QUALITY ASSURANCE -- NON-CONFORMANCE REPORT

Report No: NCR-000411

NCR #: ZPMC-0385

Reference Description: Backing bars with intermittent fillet welds in South Tower, Lift 3

WELD NUMBER: SSD1-A164H/J-194

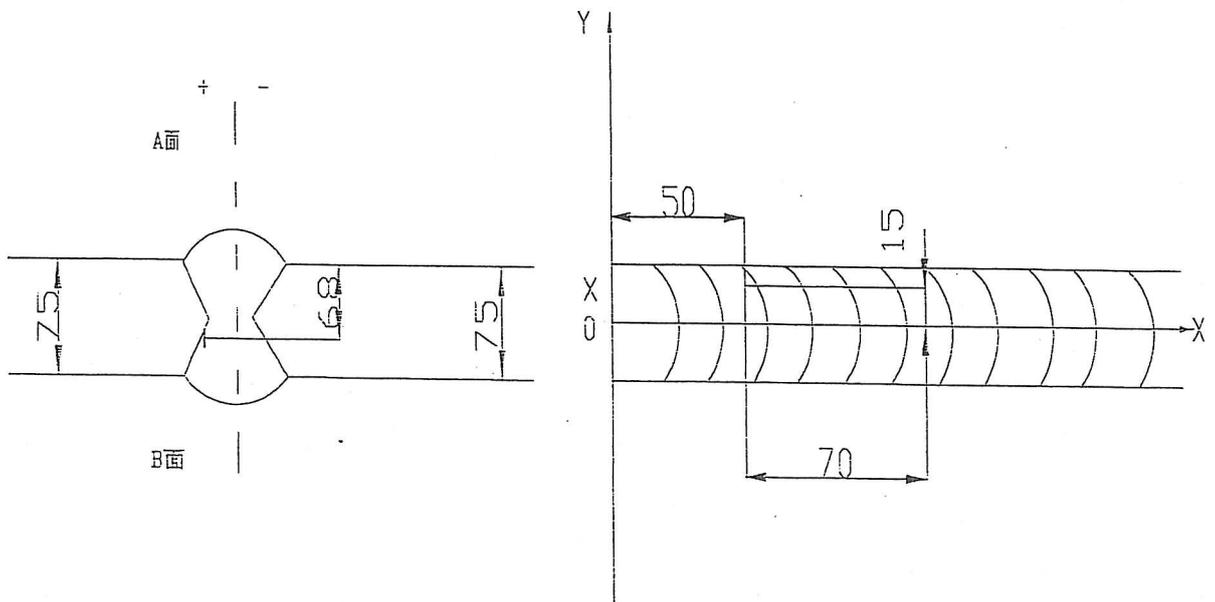
Rejected indication found by ultrasonic inspection is less than the maximum allowance aggregate length.

- 1、 碳弧气刨, 焊接接头没有有效打磨;
 - 2、 起弧和收弧没有交错布置, 以减少熔渣最少到最少;
 - 3、 焊道间没有有效的清理。
1. The weld joint was not ground sufficiently after arc-gouging.
 2. The arc starts and stops were not staggered to minimize slag entrapment.
 3. Interpass cleaning was not performed properly.

- 1、 Gouge off the defect weld;
- 2、 Grind smoothly the gouged surface;
- 3、 If User's request, check with VT or other NDT method to make sure the defect remove completely;
- 4、 Preheat and the interpass temperature control according to the relative WPS-repair;
- 5、 Check the welding according to the approved shop drawing.

1. 碳钎后的接头位置打磨更滑过渡, 保证每道焊缝的接头可以交错布置;
 2. 认真仔细检查每道焊缝和加强焊道的清理;
 3. 焊缝中所有的焊渣全部去除后, 表面的缺陷全部打磨干净.
1. The joint shall be ground to a smooth transition to ensure that arc starts and stops are in a staggered Arrangement.
 2. QC shall inspect the weld passes more carefully and enforcing interpass cleaning.
 3. All weld slag shall be removed and surface defects ground during interpass cleaning.

WELD NUMBER: SSD1-A164GJ-215

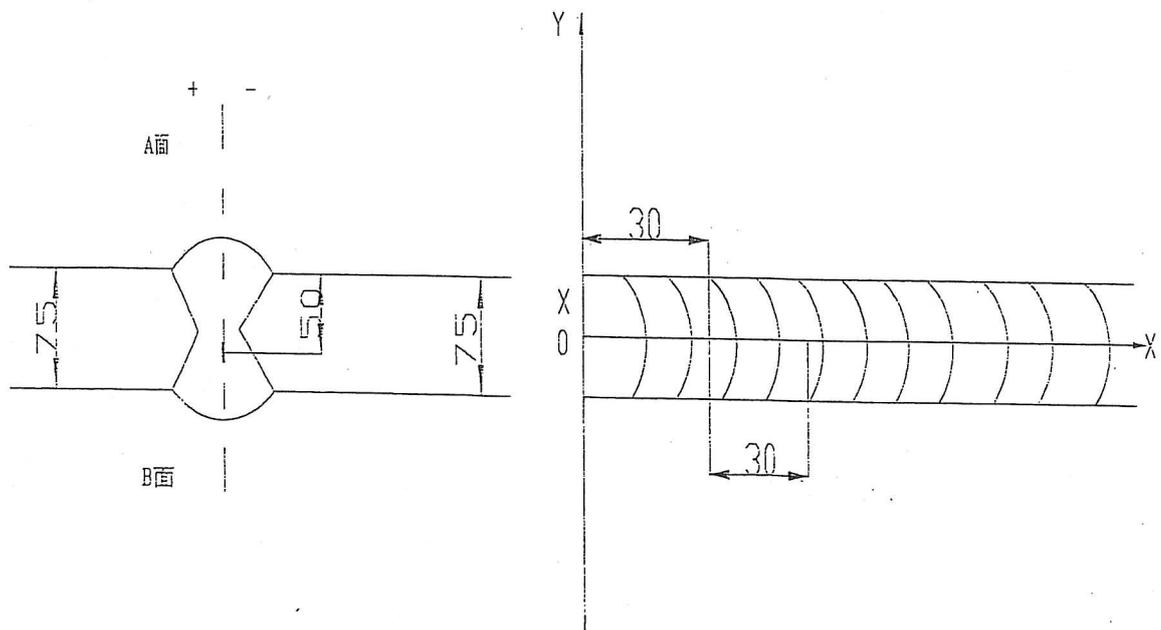
Rejected indication found by ultrasonic inspection is less than the maximum allowance aggregate length.

1. 电弧引弧时没有有效打磨。
 2. 起弧和收弧没有交错布置,以将焊缝减少到最少。
 3. 焊缝间没有有效的清理。
1. The weld joint was not ground sufficiently after arc-gouging.
2. The arc starts and stops were not staggered to minimize slag entrapment.
3. Interpass cleaning was not performed properly.

1. Gouge off the defect weld;
2. Grind smoothly the gouged surface;
3. If User's request, check with VT or other NDT method to make sure the defect remove completely;
4. Preheat and the interpass temperature control according to the relative WPS-repair;
5. Check the welding according to the approved shop drawing.

1. 碳钎后的接头位置打磨及滑过渡, 保证每道焊缝的接头可以交错布置;
 2. 认真仔细检查每道焊缝和加强焊道的清理;
 3. 焊缝中所有的焊渣全部去除后, 表面的缺陷全部打磨干净。
1. The joint shall be ground to a smooth transition to ensure that arc starts and stops are in a staggered Arrangement.
 2. QC shall inspect the weld passes more carefully and enforcing interpass cleaning.
 3. All weld slag shall be removed and surface defects ground during interpass cleaning.

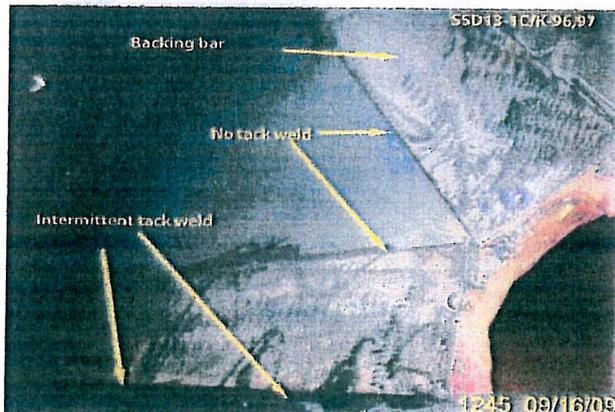
During Ultrasonic Testing (UT) of the South Tower, Lift 3 welds SST13-1C/K-96 & 97, QA discovered that backing bars have been attached with intermittent fillet welds outside of the weld joints. These weld joints were previously tested and accepted by ZPMC Quality Control Personnel.

AWS D1.5-2002, Section 3.3.7.6 - "Tack welds used to attach steel backing and placed external to the weld joint shall be made continuous by fillet welding for the full length of the backing or shall be removed."
